CAL Document Change Notification

DCN No.
7650-DCN-0069-01

CHANGE TITLE: Updates To Calorimeter Module Assembly Drawing

DOC or DWG NUMBER	TITLE	AFFECTED REV.	NEW REV.
LAT-DS-00916	Cal Module Assembly	03	04

E	LAT-DS-00916		REV 04
	CAGE CODE	SCALE: 1.000	1 OF 2

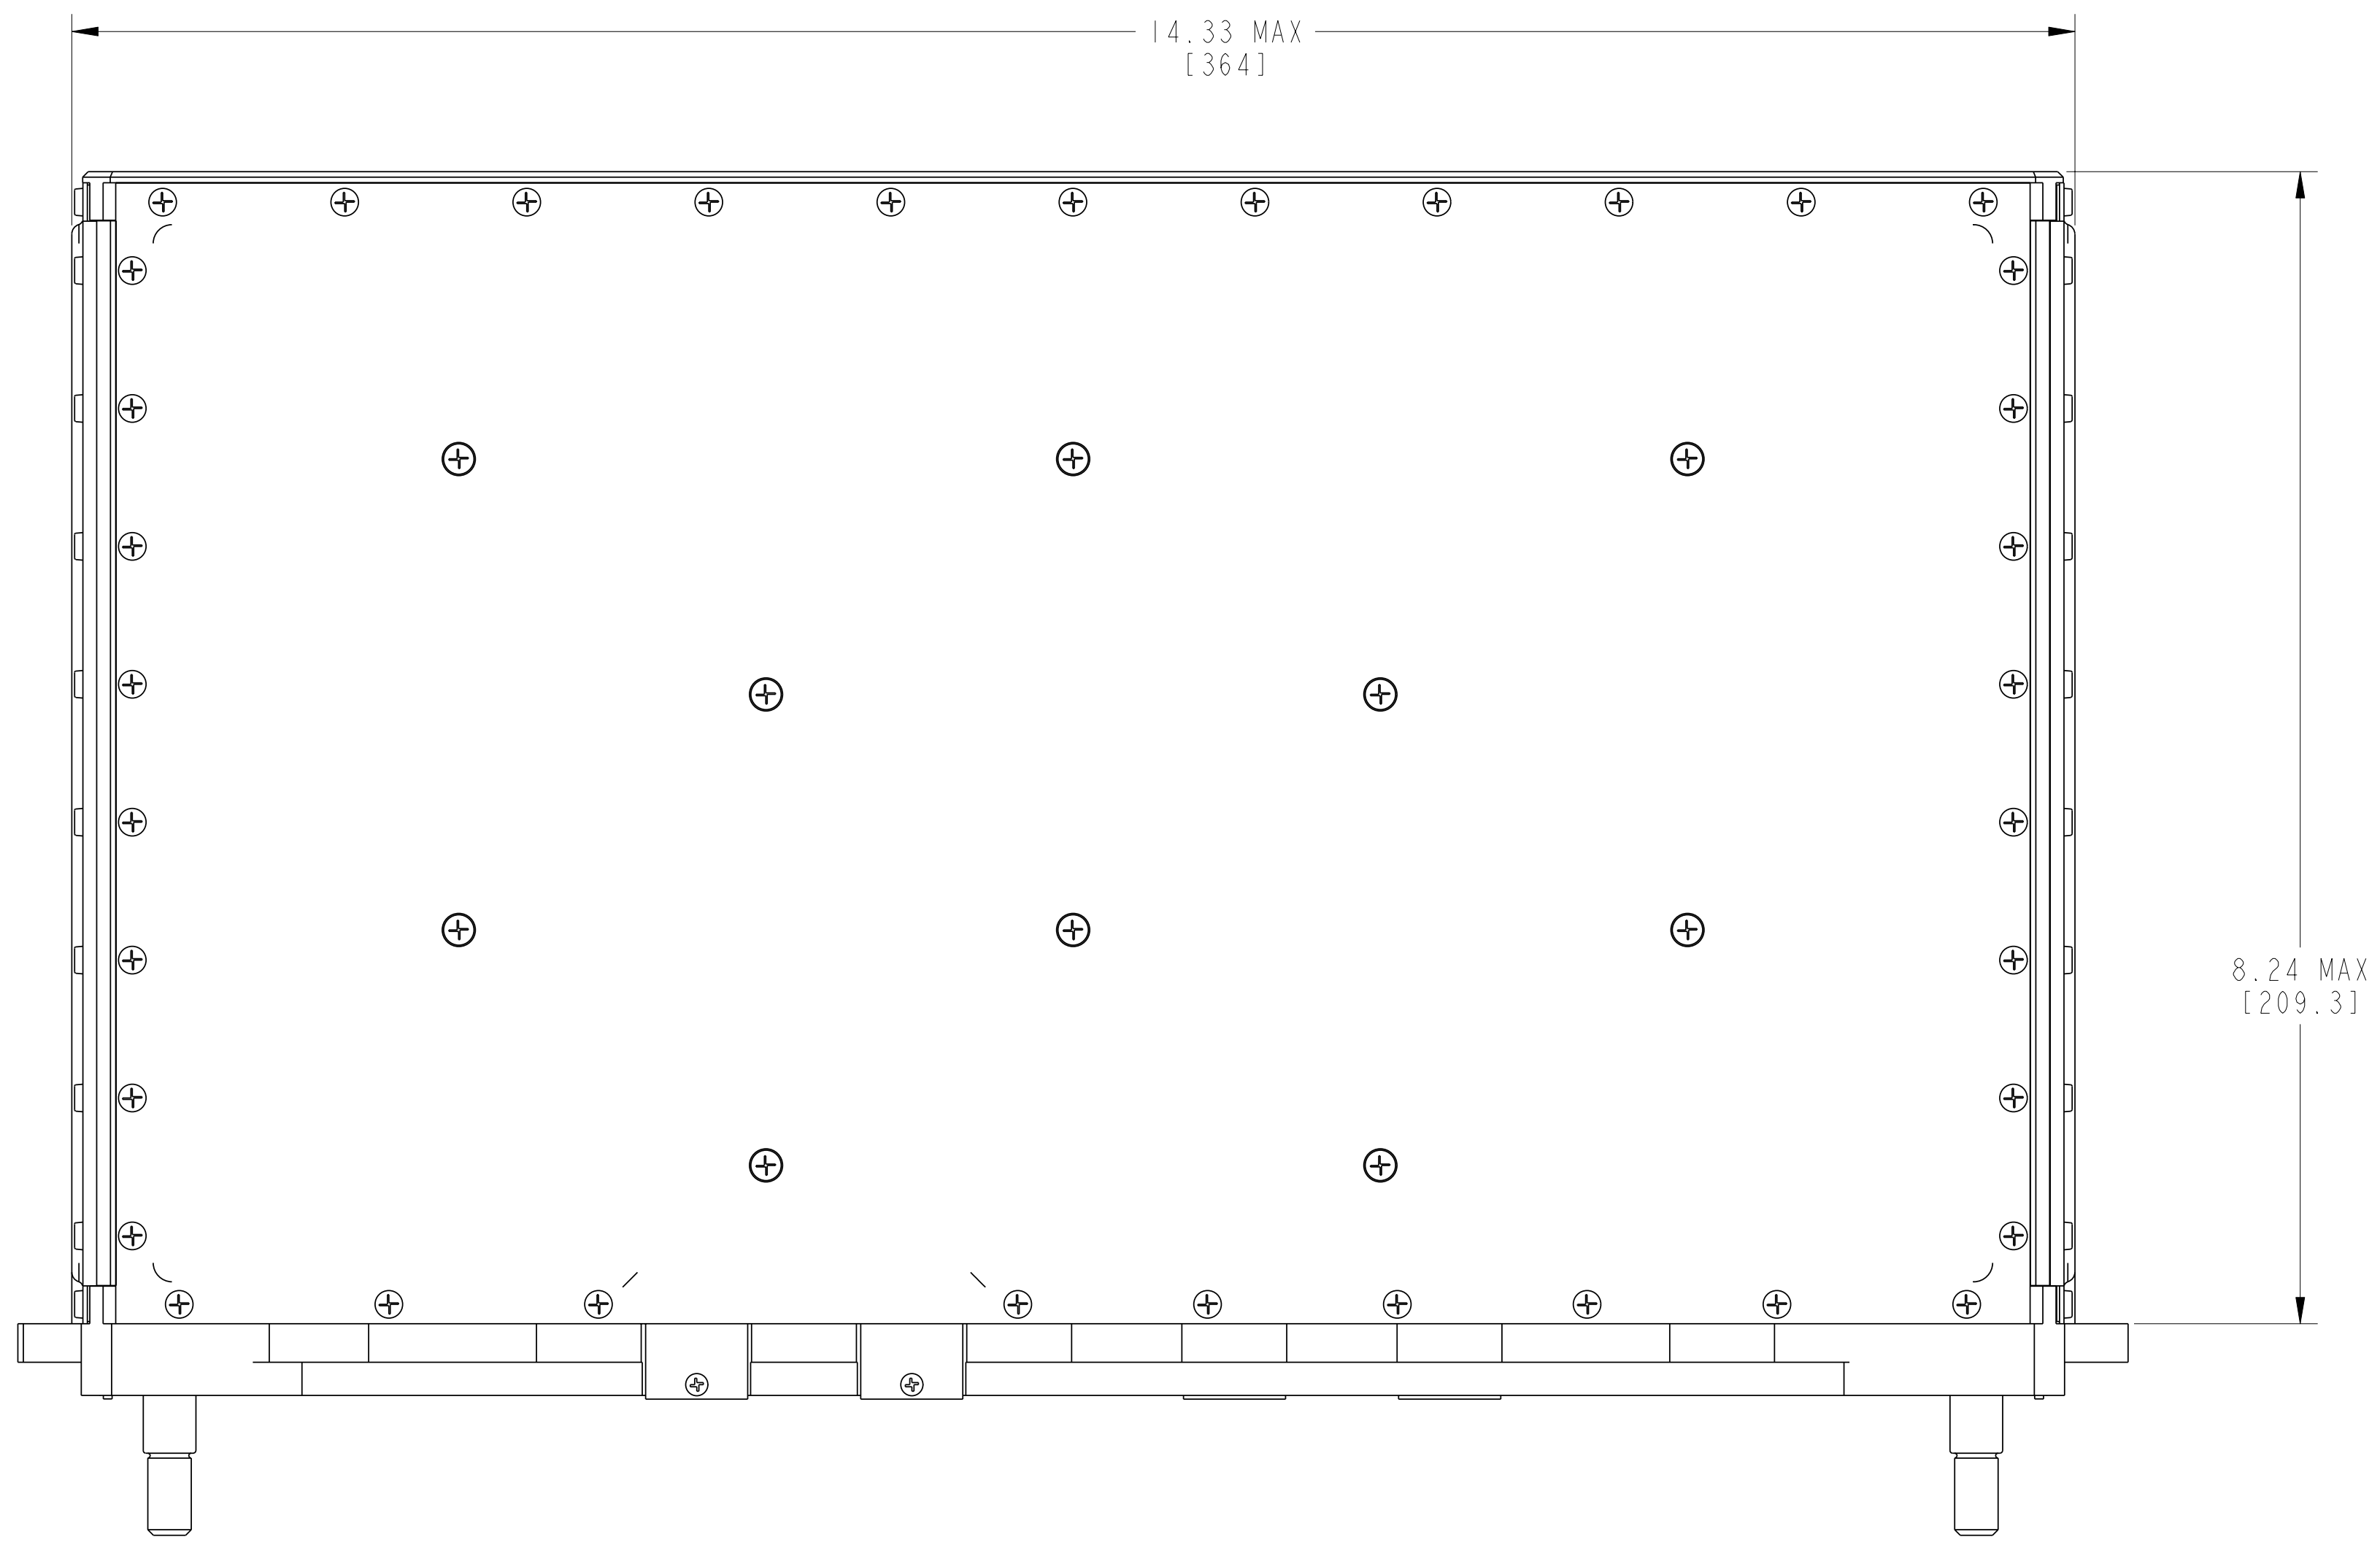
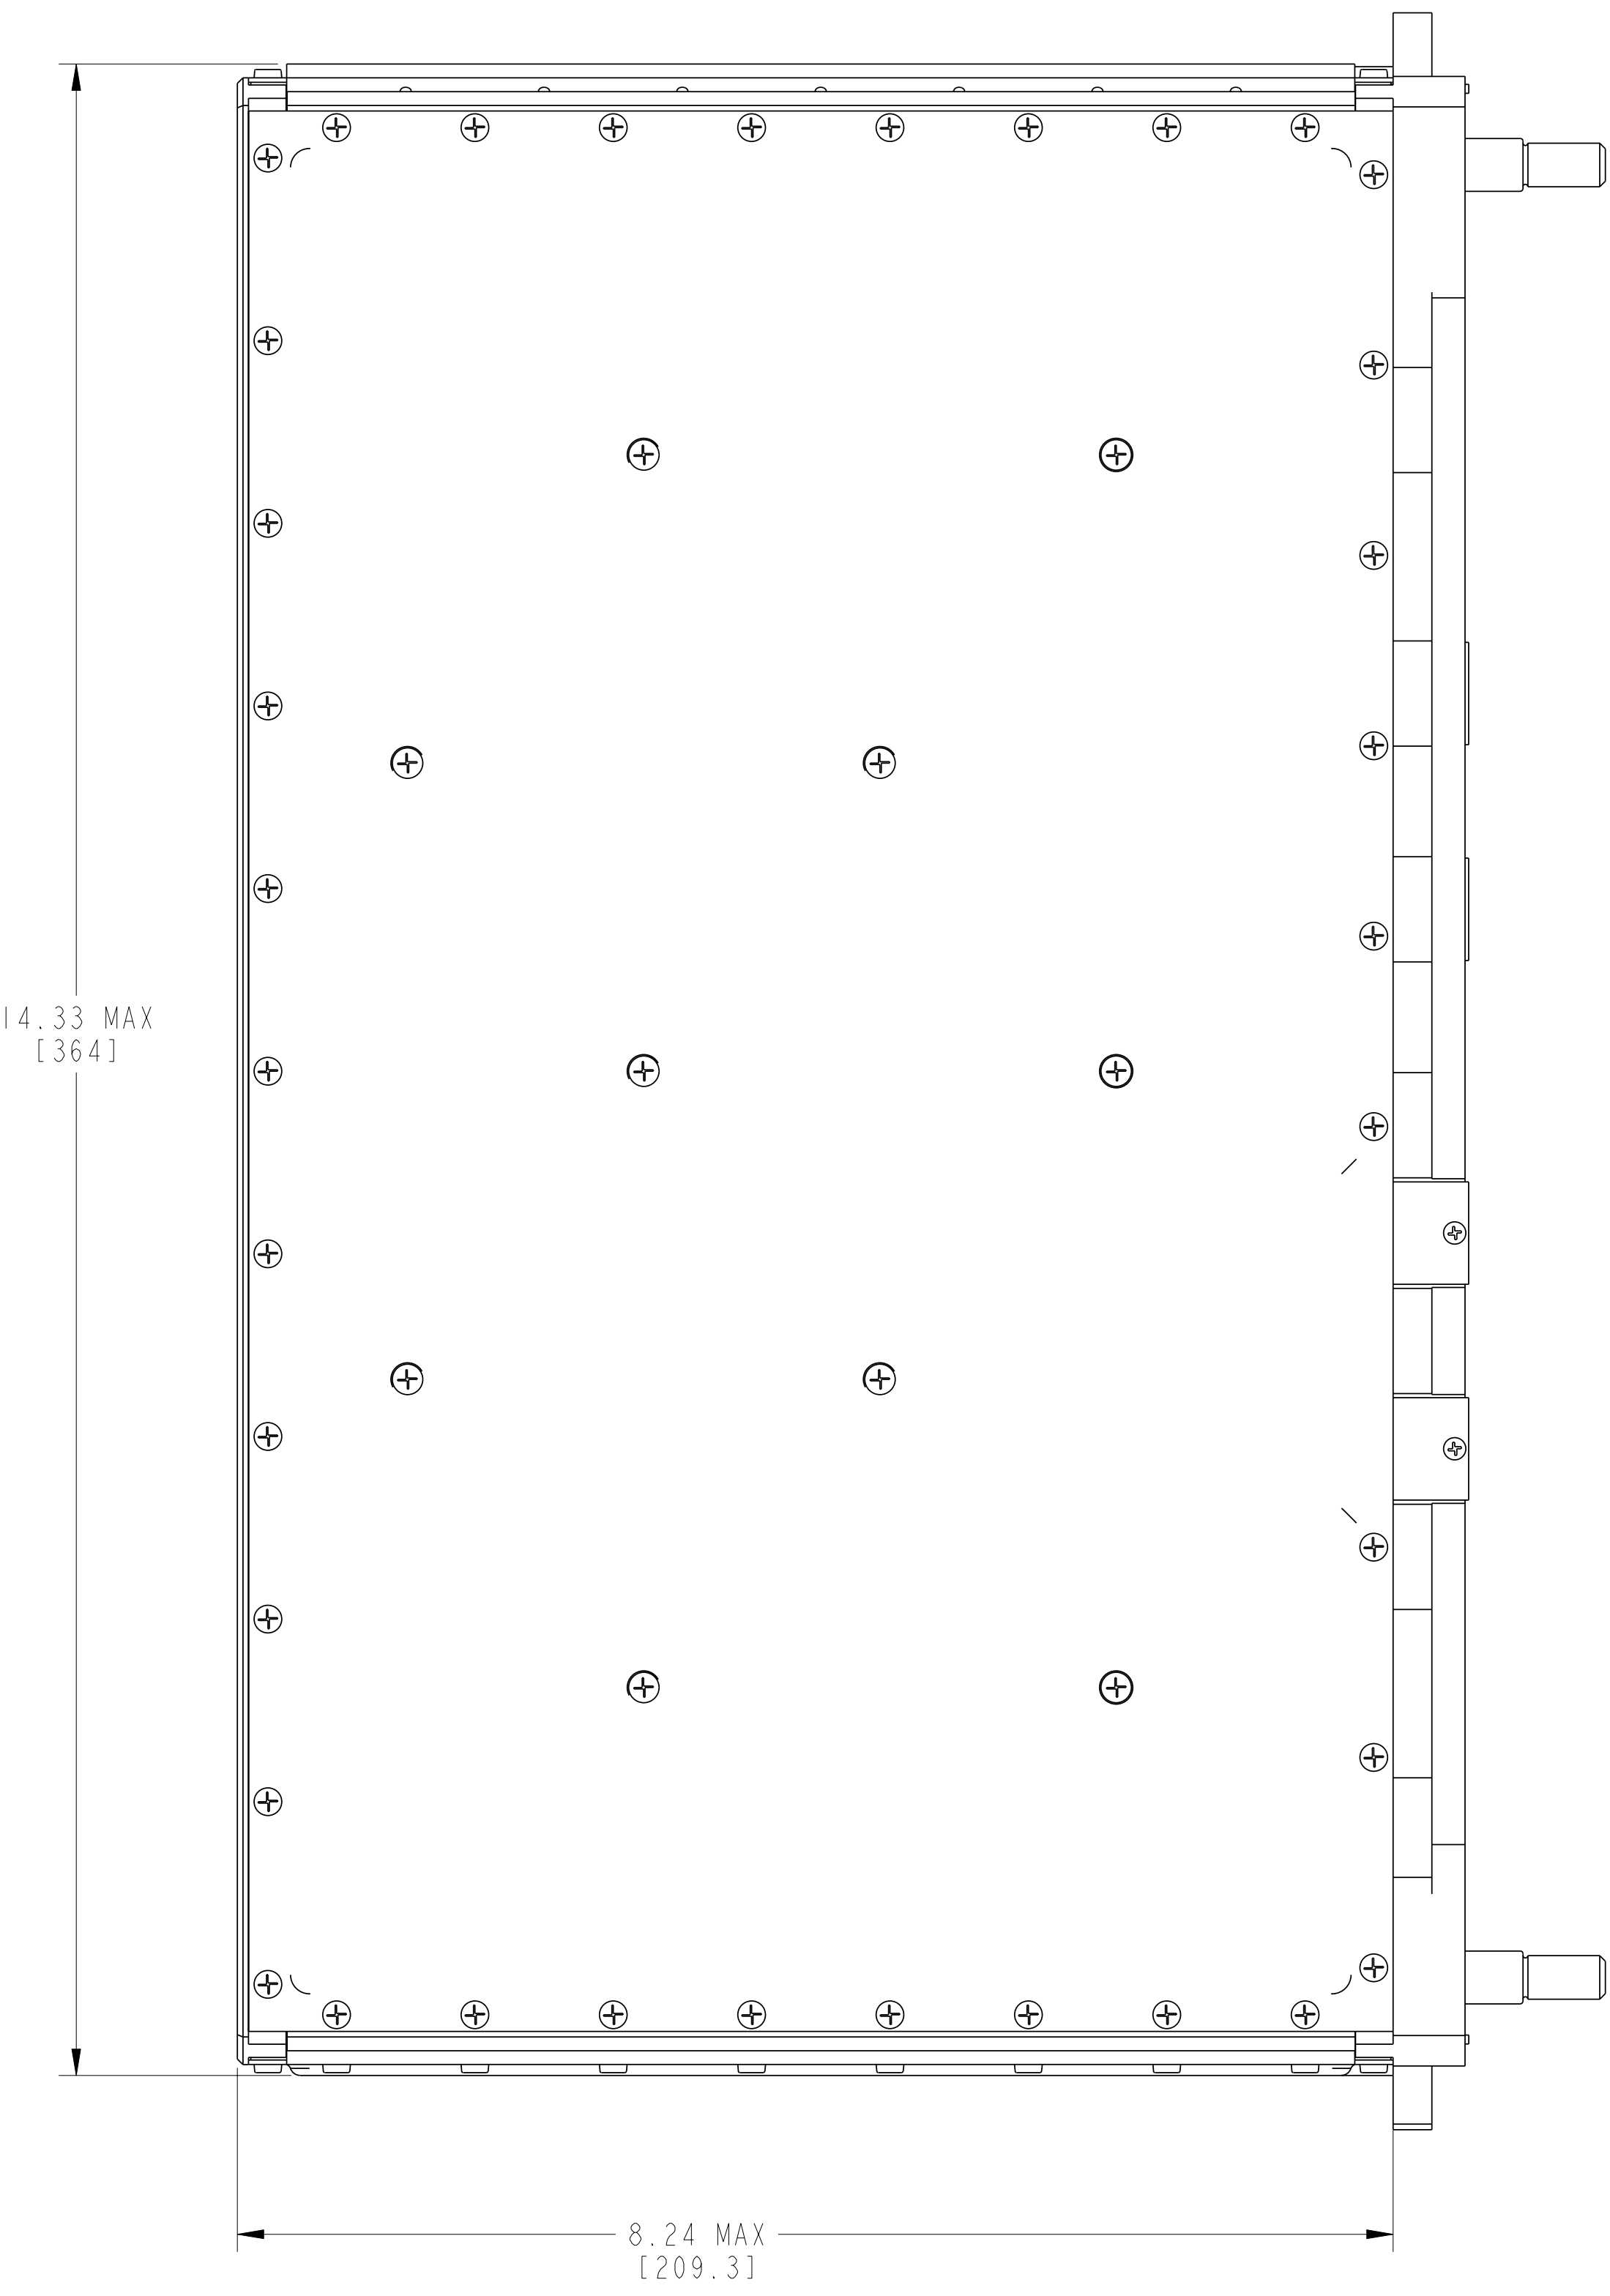
- 1) Update List of Materials with additional fasteners as shown:

REQD: 124
PART NO: NA0069-025006
DESCRIPTION: SCREW, SOCKET-HEAD, MJ2.5 x 6 mm L

REQD: 124
PART NO: 722-95-029-025-0.4B
DESCRIPTION: WASHER, FLAT, M2.5

- 2) Add Note Flag to AFEE Card Fasteners corresponding to additional parts listed in item 1)

Fasteners that secure the AFEE card to the PEM were not included in the version -03 of the drawing.
